# Revised Power Steering Oil Cooler

M-645-002

(February 2008)

All GU7 models built with an MP7 and before January 31, 2008

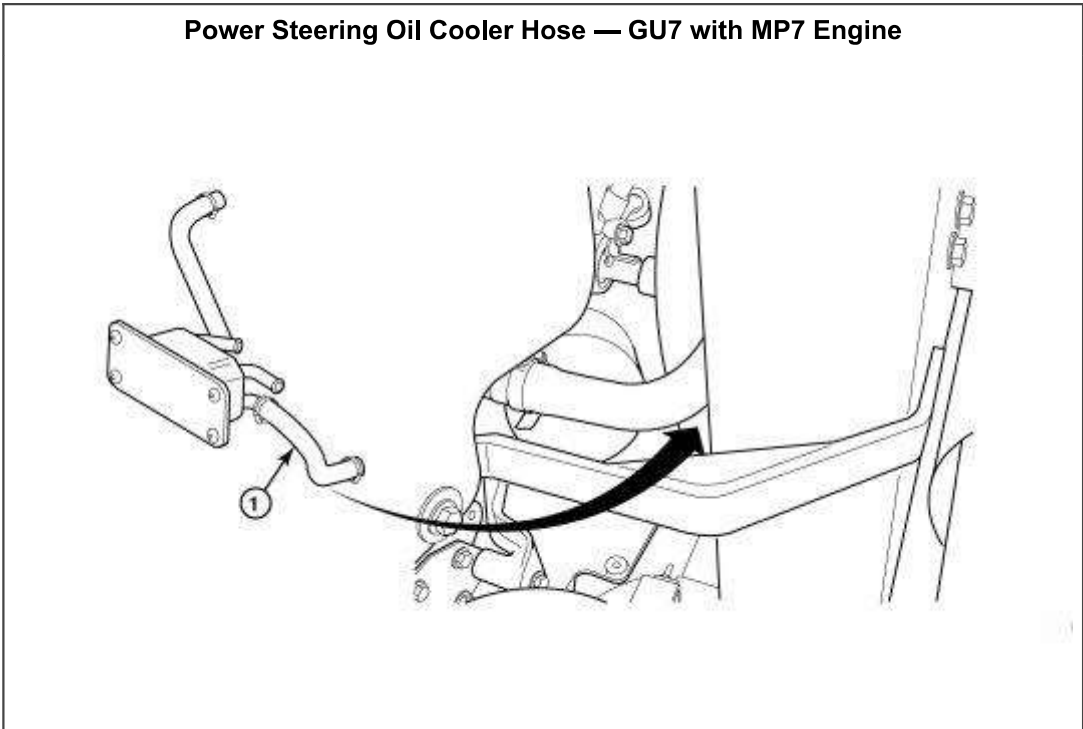
Effective January 31, 2008, a revised power steering oil cooler hose (part number 21047263) was implemented into production, replacing the original hose (part number 21047242) on GU7 model chassis equipped with an MP7 engine. This change was made to correct an interference condition that exists between the power steering oil cooler hose and the lower frame flange. Should contact between the power steering oil cooler hose and the frame rail lower flange be encountered on a chassis manufactured prior to January 31, 2008, the existing hose should be replaced with the revised hose.

| Key | Qty. | Part number | Description                            | Replaces |
|-----|------|-------------|----------------------------------------|----------|
| 1   | 1    | 21047263    | Hose, lower, power steering oil cooler | 21047242 |
